Ecological Risk Assessment Work Plan Addendum 350 Knotter Drive Cheshire, Connecticut

ENSR Corporation
July 2008
Document No.: 00489-014-400a

Attachment 1 Agency Comments on the Draft Ecological Risk Assessment Work Plan

Attachment 2 Preliminary Responses to Agency Comments on the Draft Ecological Risk Assessment Work Plan

Figure 2

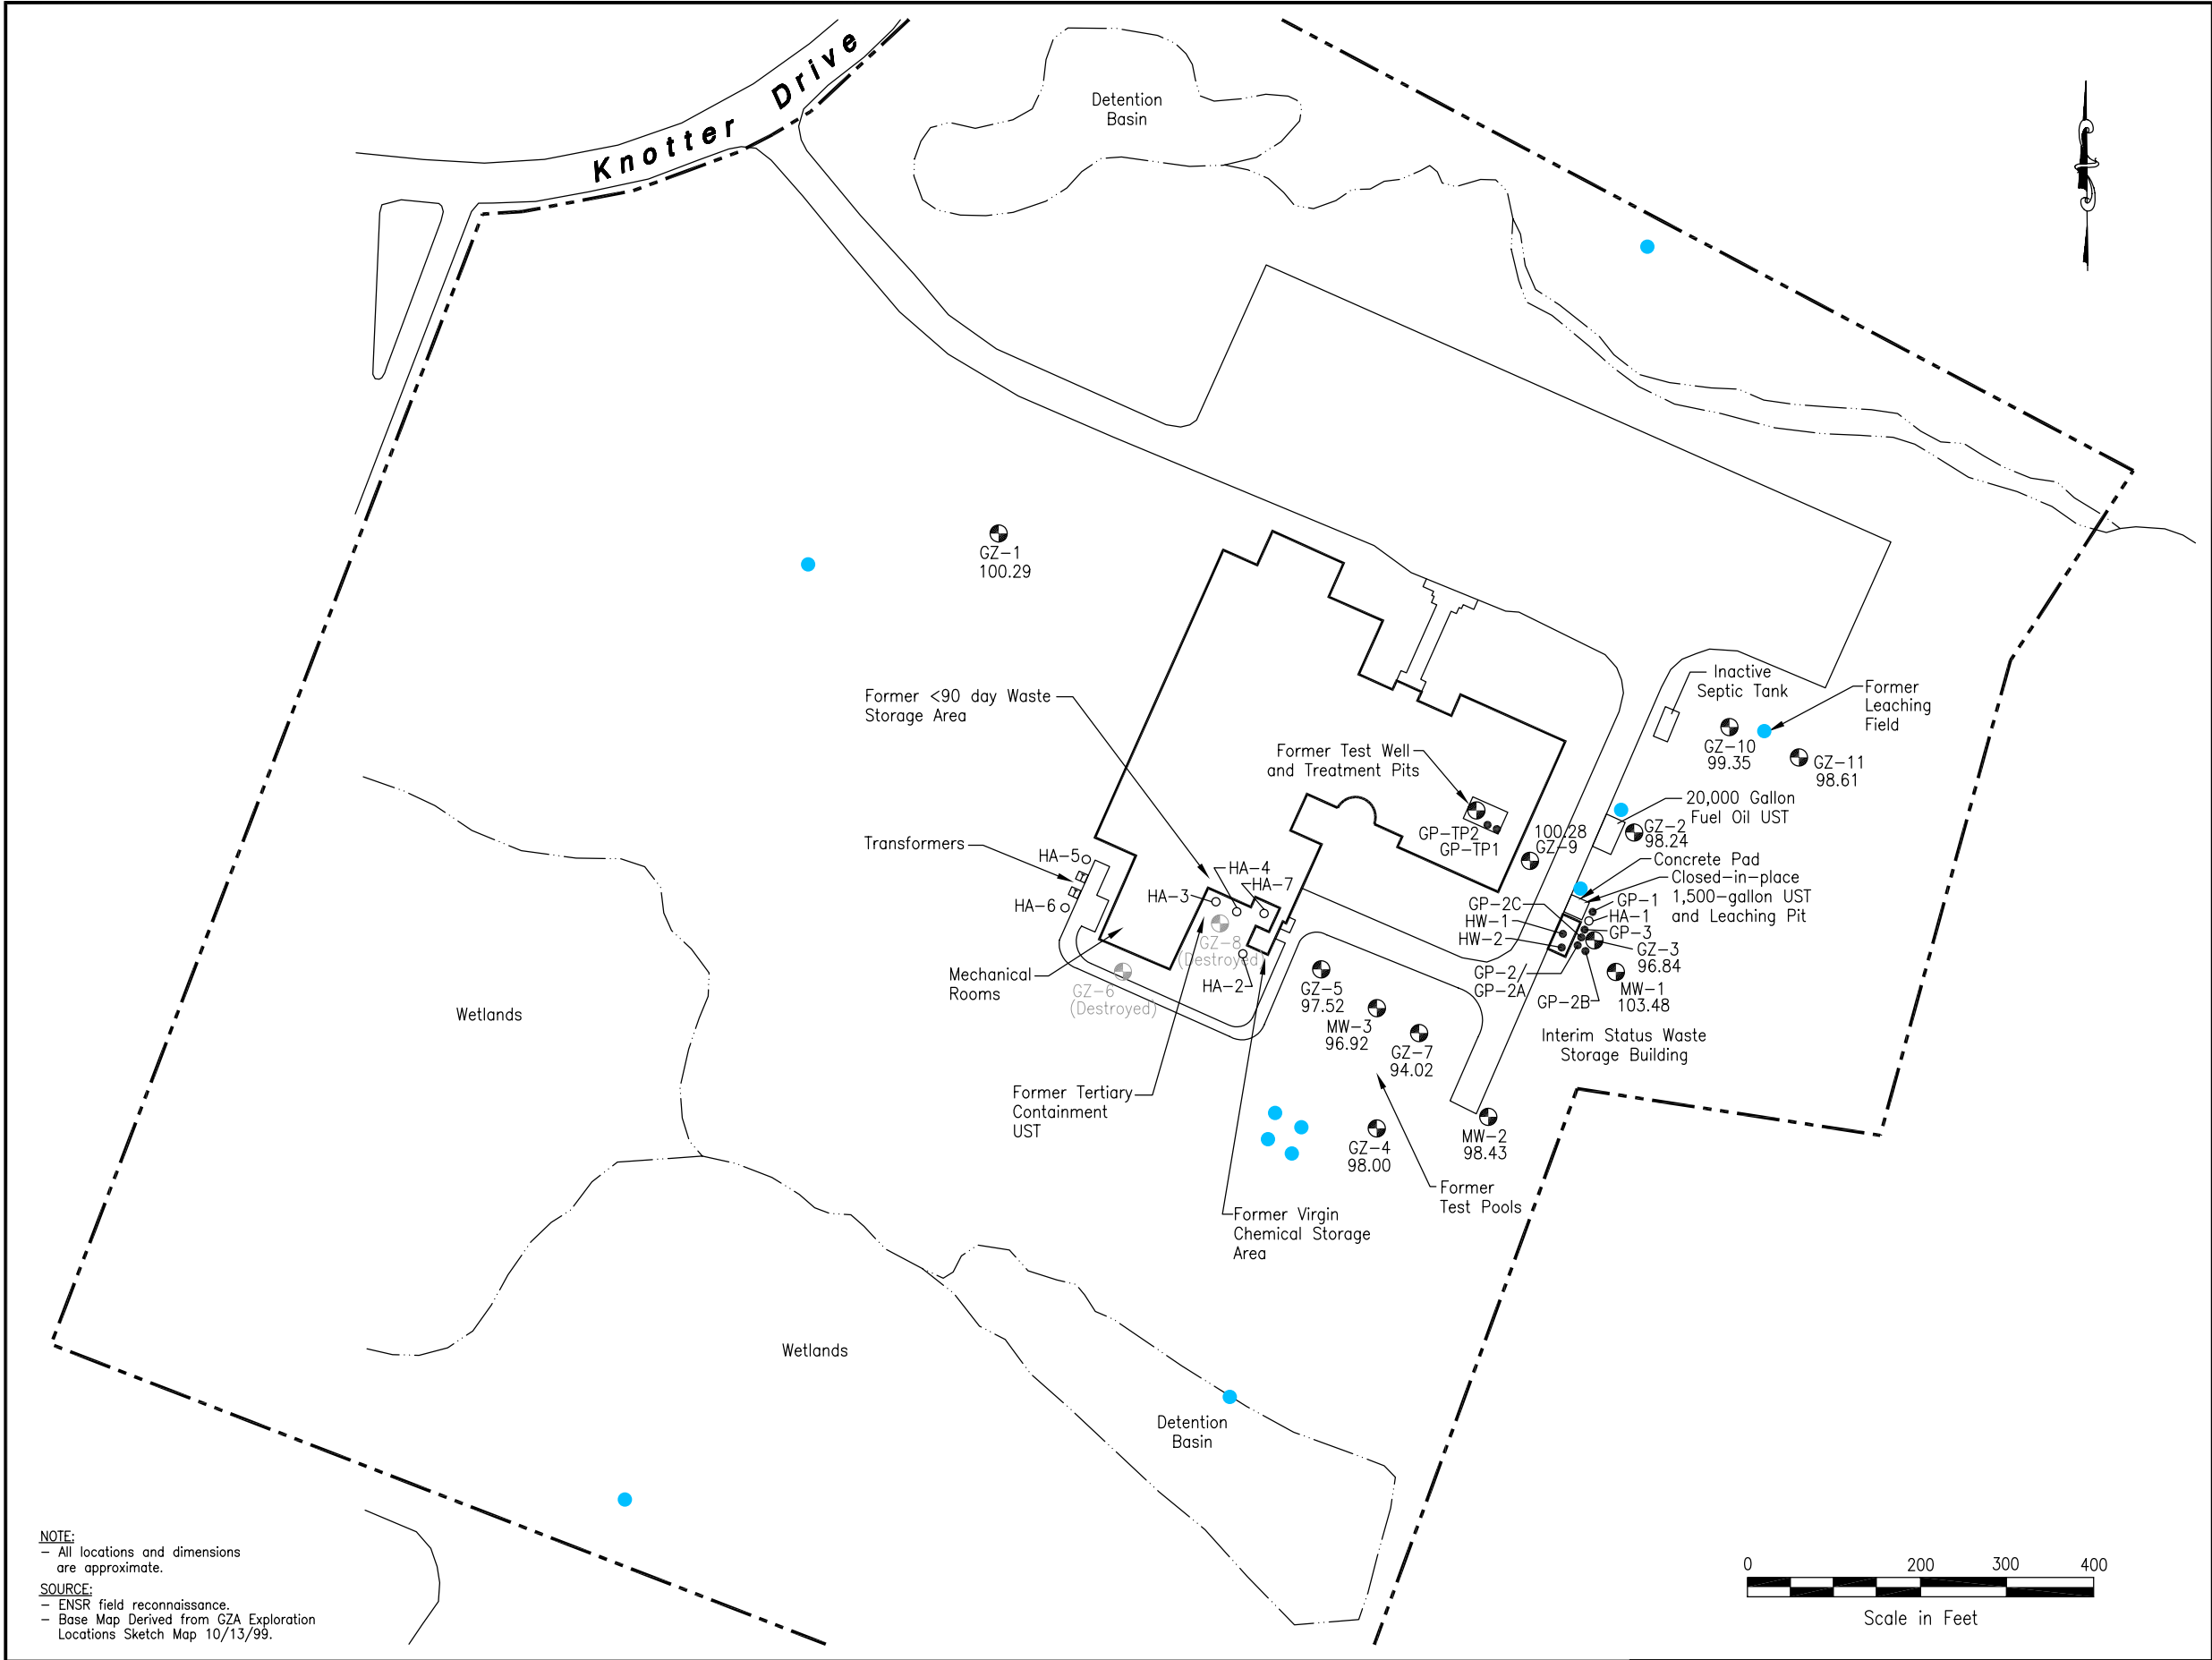
Figure 2 (Site Plan) included in the WP did not show the location of this drainage ditch. The WP also did not indicate where this water flowed. This information needs to be included and fully described in the WP. Depending upon this information, considering the volume of flow, the contaminants, and the duration of the discharge it is likely that sampling and analysis of the appropriate media at the point of discharge may be necessary.

Figure 2 presents the proposed soil sampling locations. A series of three samples will be collected from the eastern portion of the property in the vicinity of the former leaching field and two underground storage tanks (USTs). Four samples will be collected in the area of the historic drainage ditch which reportedly discharged chiller condensate and non-contact cooling water into the southern detention basin.

The ditch has not been used in approximately 15 years and was not readily apparent during a 2007 site visit conducted prior to the SERA work plan development. However, the area between the south of the building and the southern detention pond will be examined in detail for evidence of the former drainage ditch and four samples will be collected in order to assess potential soil impacts due to the historic discharge. In addition, a soil sample will be collected from the bank of the detention pond approximately where the former drainage ditch was most likely to have discharged into the pond (as best can be determined from a visual inspection and from the 1983 Site Plan).
